SUB-COMMITTEE ON SHIP DESIGN AND
CONSTRUCTION
8th session
Agenda item 16

SDC 8/16
12 October 2021
Original: ENGLISH
Pre-session public release:

Maintenance of the Revised guidance on shipboard towing and mooring equipment (MSC.1/Circ.1175/Rev.1)

Submitted by IACS

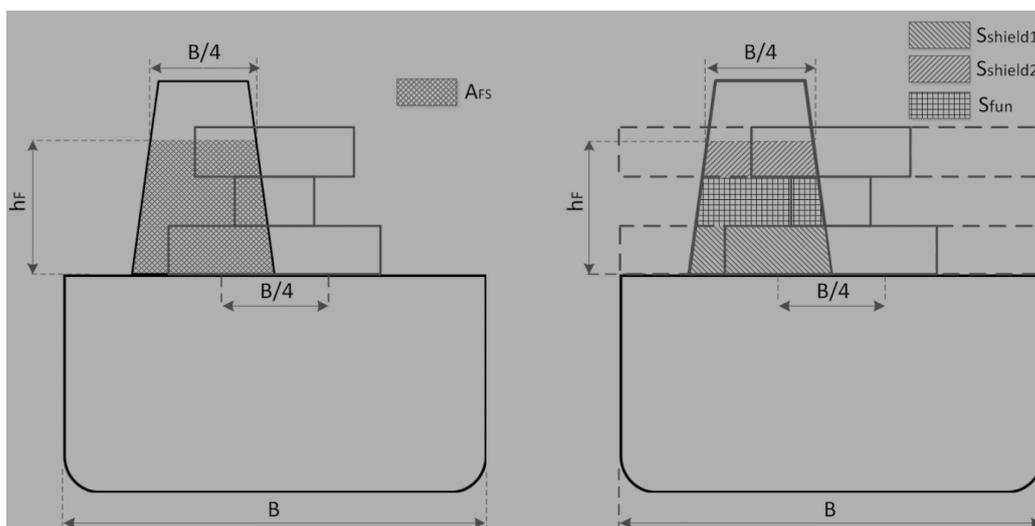
8 With revision 7 of UR A1, the definition of the Equipment Number was updated to consider increased funnel sizes due to the installation of equipment such as SO_x scrubbers. In the proposed revision of MSC.1/Circ.1175/Rev.1 this update was included in appendix B "Equipment Number".

S_{fun} = Effective front-projected area of the funnel, in square metres, defined as:

A_{FS} = Front-projected area of the funnel, in square metres, calculated between the upper deck at centreline, or notional deck line where there is local discontinuity in the upper deck, and the effective height h_F . A_{FS} is taken equal to zero if the funnel breadth is less than or equal to $B/4$ at all elevations along the funnel height.

h_F = Effective height of the funnel, in metres, measured from the upper deck at centreline, or notional deck line where there is local discontinuity in the upper deck, and the top of the funnel. The top of the funnel may be taken at the level where the funnel breadth reaches $B/4$.

$$EN = \Delta^{2/3} + 2.0(hB + S_{fun}) + \frac{A}{10}$$

$$S_{fun} = A_{FS} - S_{shield}$$

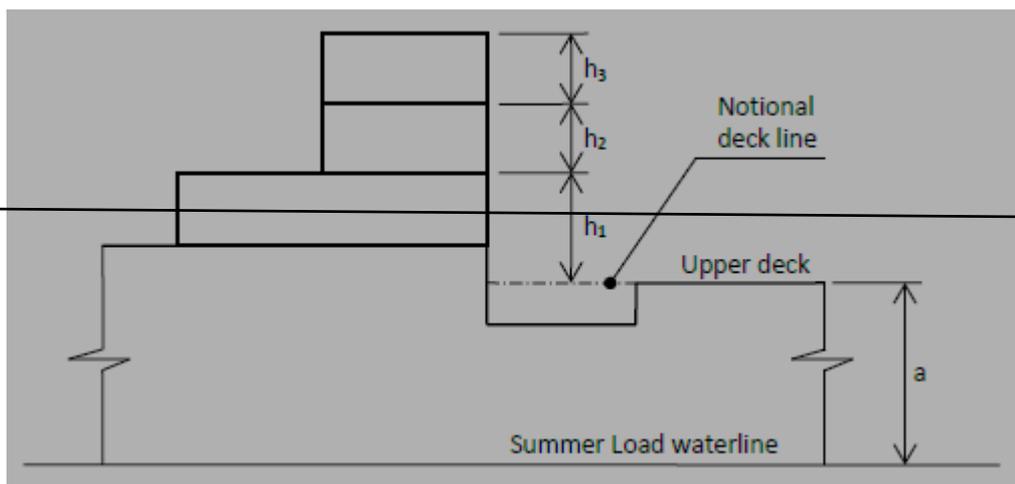
S_{shield} = The section of front-projected area A_{FS} , in square metres, which is shielded by all deck houses having breadth greater than $B/4$. If there are more than one shielded section, the individual shielded sections i.e $S_{shield1}$, $S_{shield2}$ etc., as shown in the figure below, to be added together. To determine S_{shield} , the deckhouse breadth is assumed B for all deck houses having breadth greater than $B/4$ as shown for $S_{shield1}$, $S_{shield2}$ in figure below.

A = Side-projected area, in square metres, of the hull, superstructures, and houses and funnels above the Summer Load Waterline which are within the equipment length of the ship and also have a breadth greater than $B/4$. The side-projected area of the funnel is considered in A when A_{FS} is greater than zero. In this case, the side-projected area of the funnel should be calculated between the upper deck, or notional deck line where there is local discontinuity in the upper deck, and the effective height h_F .
